From: Residents of South Main Street, Haydenville

Date: November 15, 2023

We the undersigned residents, property/business owners and supporters of South Main St. in Haydenville believe that **safety concerns** about the lower S. Main St. pedestrian+bike path **have not been adequately addressed.**

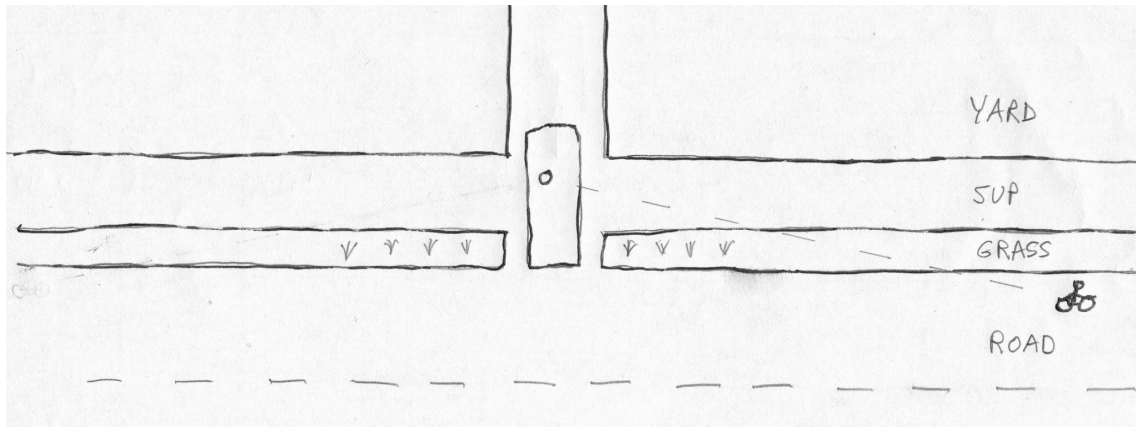
A bicycle traveling at even 5 MPH moves more than 7 feet every second. If it takes a driver 7 seconds to look over their shoulder to the left checking for bikes, then look to the right, then begin backing up, a bicycle going 5 MPH will have traveled 50 feet since the driver looked to the left. With a car halted in a driveway at the edge of the shared-use path, the driver is probably 7 to 12 feet away from the edge of the path (for car vs. pickup truck). The scale diagram below shows the geometry of the situation:

The shaded area must be free of visual obstructions for the driver to be able to see a cyclist within collision range when backing up. Nearly all of the houses along S. Main St. have fences, foliage, between-property hedges/trees, or adjacent buildings in this region. (See Appendix A below.) These cannot simply be “trimmed,” as the Greenway

committee suggests; a good deal of the neighborhood's character would have to be changed in order for drivers to see bicyclists on the proposed path.

It is important to note that the hazard here is greater for children than for adults. Children are shorter and thus more likely to be obscured by low obstacles, and they are less likely to understand the critical importance of stopping quickly if a car in a driveway is moving towards the path.

In general, a safely-designed path designated for bicycle use which is crossed by driveways must be set back from any visual obstructions by a distance equal to the largest expected distance between a driver and the bumper of their vehicle.
